WRITTEN STATEMENT FOR THE STAGE TWO HEARINGS OF THE VALE LOCAL PLAN

MATTER 9 (J) EAST SUTTON COURTENAY SITE

Location : Land off Hobbyhorse Lane Sutton Courtenay Abingdon OX14 4BB
Proposal : Outline planning application for up to 200 dwellings, including vehicular access, pedestrian and cycle links, public open space, car parking, landscaping, drainage and associated works.

Planning Application P15/V2353/O, Land at Hobby Horse Lane, Sutton Courtenay

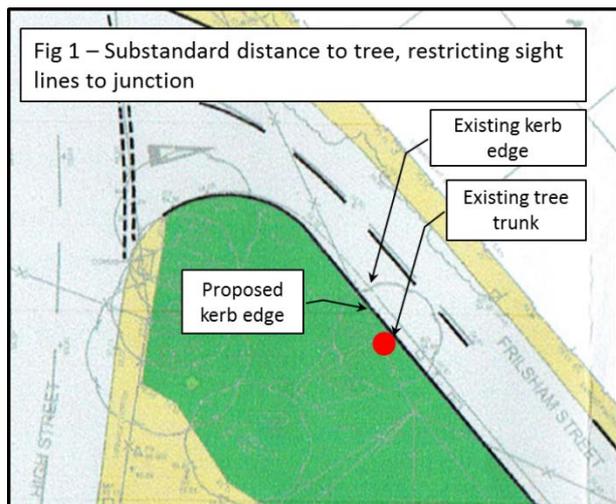
- 1 a carriageway width of less than 5 metres throughout its length,
- 2 substandard footways of 1.5m wide
- 3 on street parking allowed on both sides of the carriageway

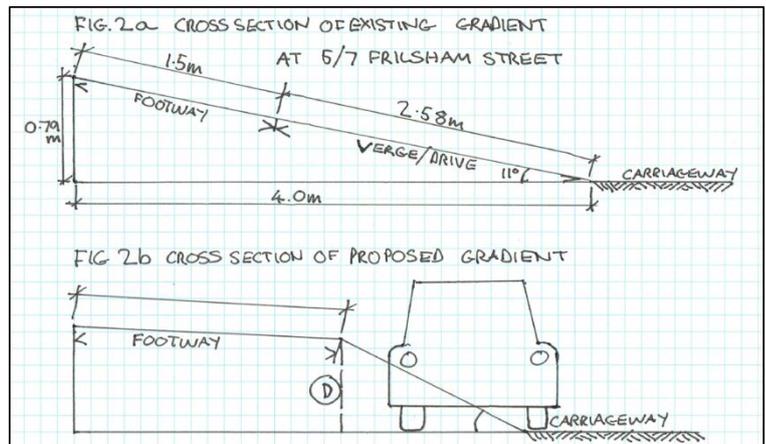
- 5 The next issue starts on Frilsham Street some 50m from the junction with High Street, but on the north side of the carriageway. From number 3 Frilsham Street to the corner with Town Close, the verge/footway is situated on a slope whose crossfall is around 10%. The slope also accommodates vehicular access to some of the properties with dropped kerb access. The tarmac footway is currently substandard both in its own crossfall and width (see fig.2a).

- i. If the scheme goes ahead, and the layout must encourage walking, as the proposal claims, then the extra footfall and the ability to accommodate double buggies passing each other, a footway that complies with standards must be introduced. This should be a 2m wide footway with a max crossfall of 3.3% (as shown in fig. 2b.).

- ii. If the above is accommodated then the 1.5m parking strip (which should use the same crossfall as the footway) would have a vertical drop to it of up 0.6m (see fig. 2b at D) and this would be in place for the 20m of the parking strip.

- v. Further, car occupants would have to then walk into the live carriageway to access the footway as to scale the retaining wall at D would not be possible.
